SIB 61 23 20

RECALL 20V-601: HIGH-VOLTAGE BATTERY RECALL

This Service Information Bulletin (Revision 6) replaces SI B61 23 20 **dated December 2020**.

SP44 HV Battery (G05) modules-

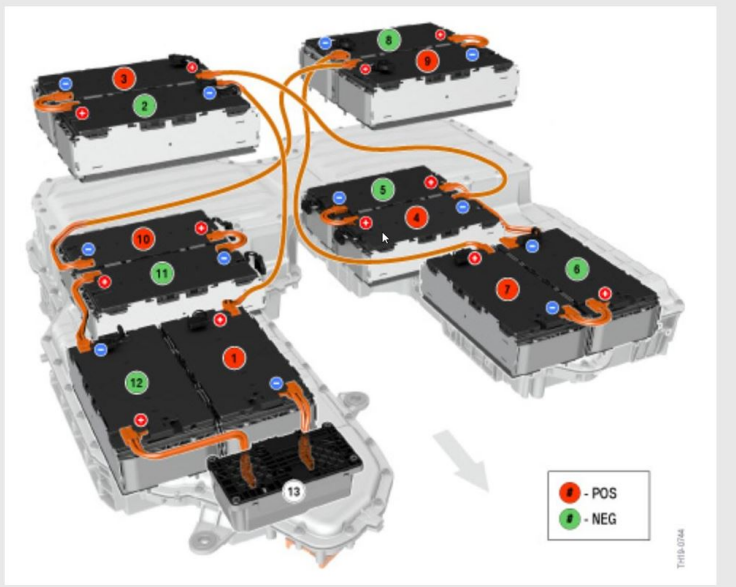
Modules are designed as Positive and Negative modules (with different orientation and part numbers). When replacing modules, verify in EPC the correct part (POS/NEG) and reinstall according to their original position. See below.

Use EPC diagram to verify the correct module part number (01/02) for NEG or POS modules.

Use the illustration on the right to match the part# with the correct module installation location.

- Module 12 is **NEG (01)**
- Module 1 is **POS (02)**
- Module 11 is **NEG (01)**
- Module 10 is **POS (02)**
- Module 2 is **NEG (01)**
- Module 3 is **POS (02)**
- Module 8 is **NEG (01)**
- Module 9 in **POS (02)**
- Module 5 is **NEG (01)**
- Module 4 is **POS (02)**
- Module 6 is **NEG (01)**
- Module 7 in **POS (02)**

SP41 HV Battery (G01/G20/G20/G12) modules-

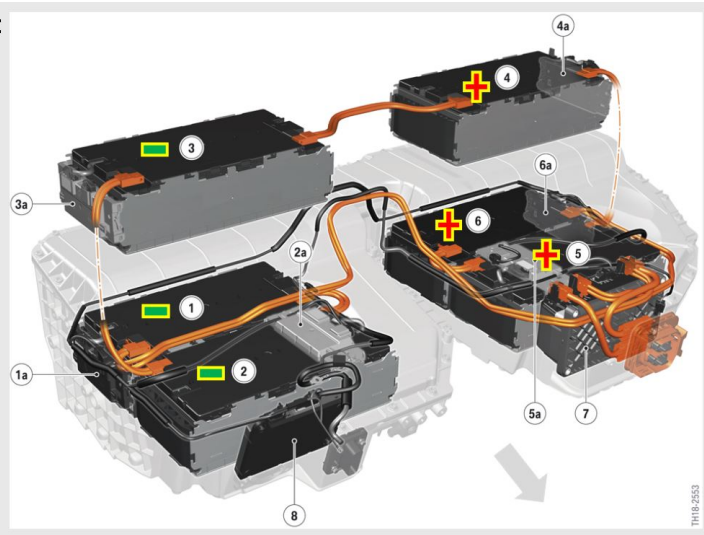
Use EPC diagram to verify the correct module part number (01/02) for NEG or POS modules.

Use the illustration on the right to match the part# with the correct module installation location.

- Module 1 is **NEG (01)**
- Module 2 is **NEG (01)**
- Module 3 is **NEG (01)**
- Module 4 is **POS (02)**
- Module 5 is **POS (02)**
- Module 6 is **POS (02)**
